# 435 DEXTER

August 6, 2014  
Design Review  
Recommendation #2  
DPD Project# 3016347

South Elevation: Summary of Responses to Recommendation

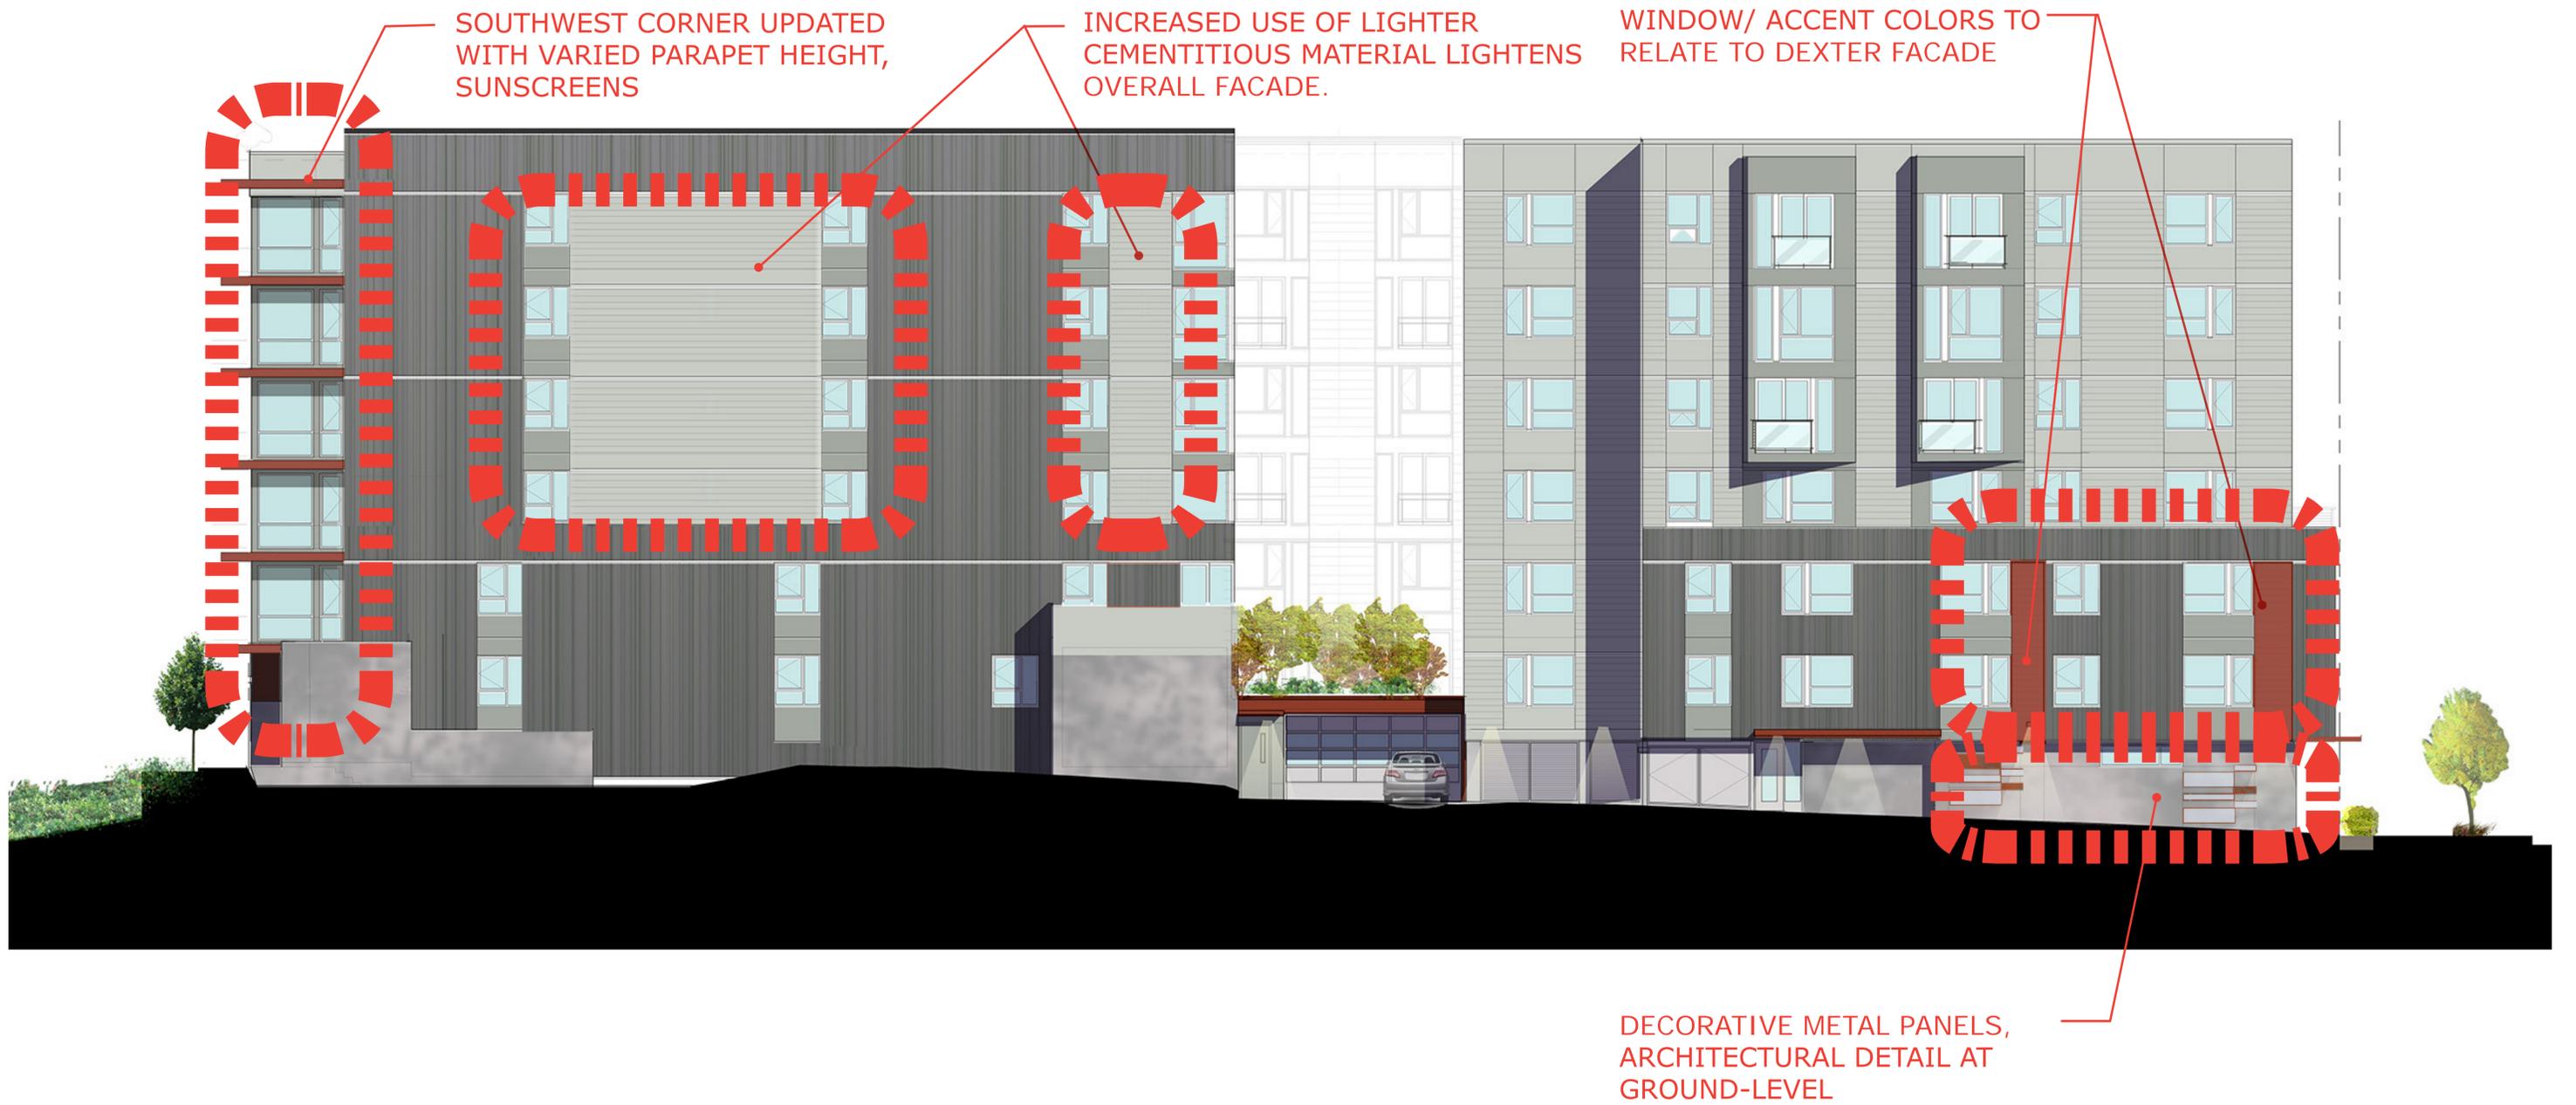
#### 4. Alley: *Initial Recommendation*

- Wrap Dexter Ave facade treatments at Levels 2 & 3 around to alley side for at least one bay width.
- Ground-level facade between Dexter and alley exit door should be human-scaled

#### 4. Alley: Applicant Response

- Alley facade at Levels 2 & 3 continues the Dexter Ave facade treatment.
- Ground-level facade incorporates architectural detail and decorative screens to enhance the pedestrian and cyclist environment.

Current 8/6/14 Alley View toward Alley Exit Door

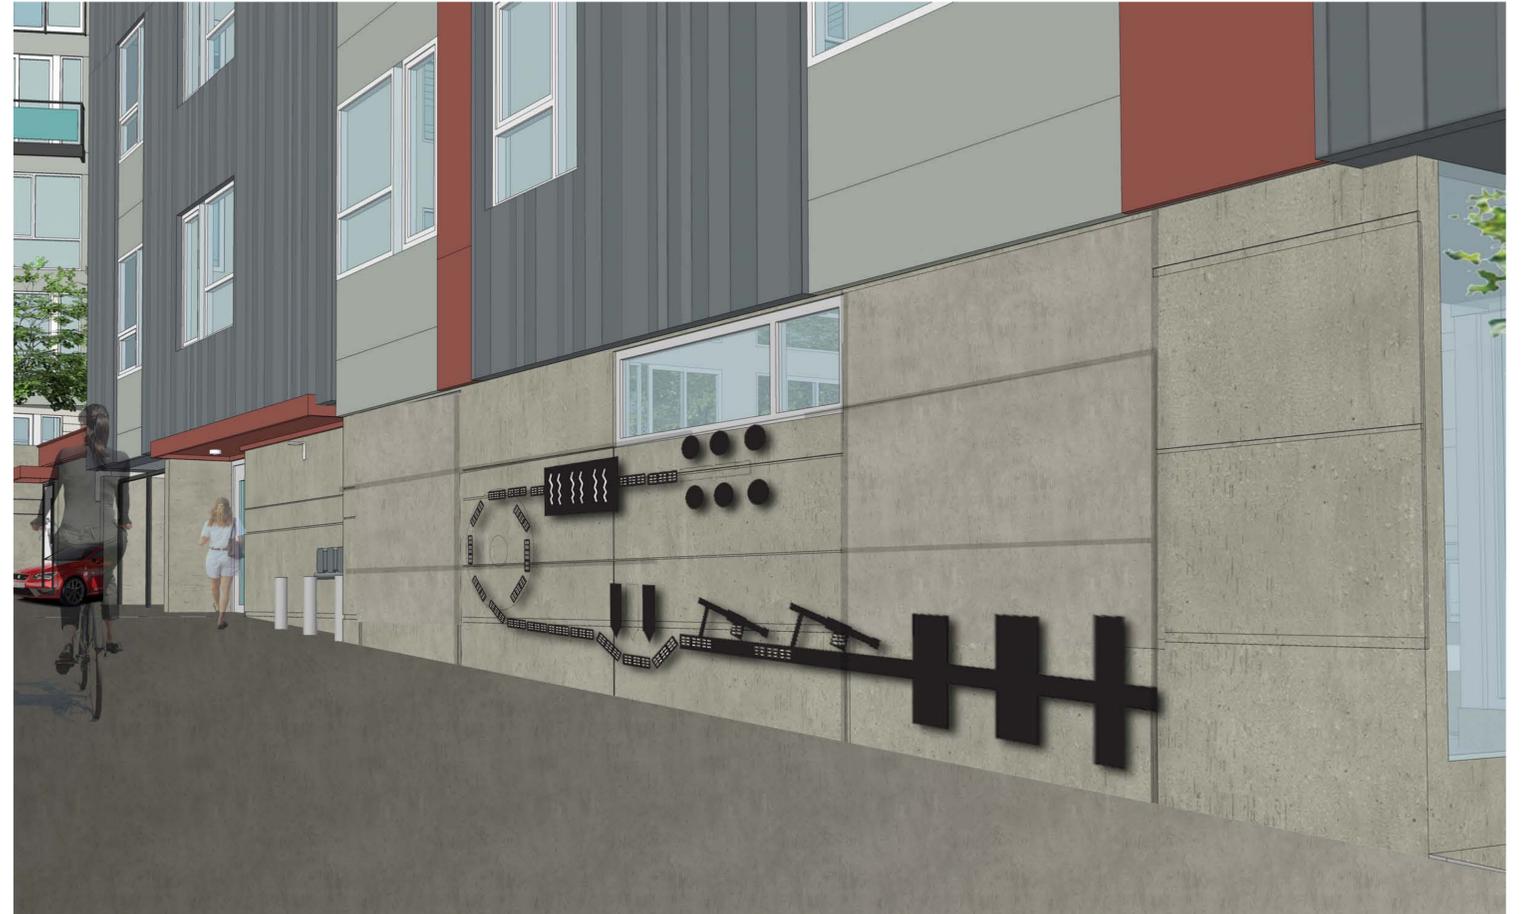
#### 4. Alley: Initial Recommendation

- Ground-level facade between Dexter and alley exit door should be human-scaled

#### Applicant Response

- Ground-level facade incorporates architectural detail and decorative screens to enhance the pedestrian and cyclist environment.

DECORATIVE METAL SCREENS & CONCRETE REVEAL DETAILS AT GROUND LEVEL TO RELATE TO DEXTER AVE METAL SCREENS

INITIAL RECOMMENDATION: SIGNAGE

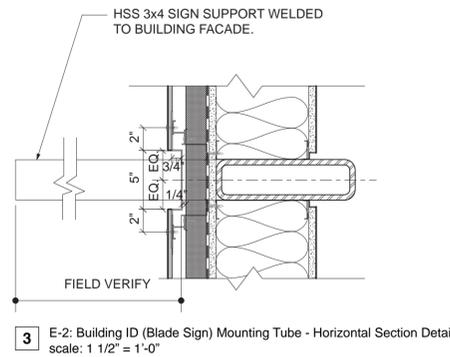
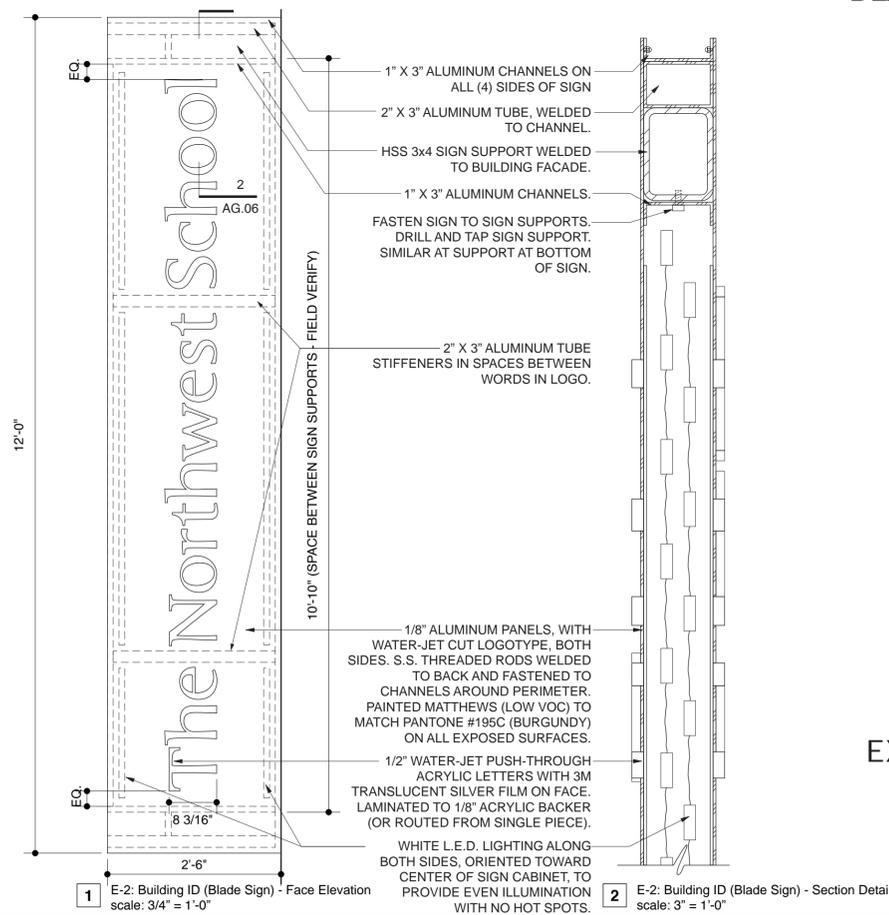
- 6. Signage.** The Board recommended further development of the building identification signage, including pedestrian scale signage at the Dexter Ave N canopy, and upper level building signage that is creatively designed and integrated into the building design. The signage should be located to minimize any visual impacts to future residents of the proposed building. (D-9)

BLADE SIGN AT NW CORNER

BLADE SIGN AT SW CORNER
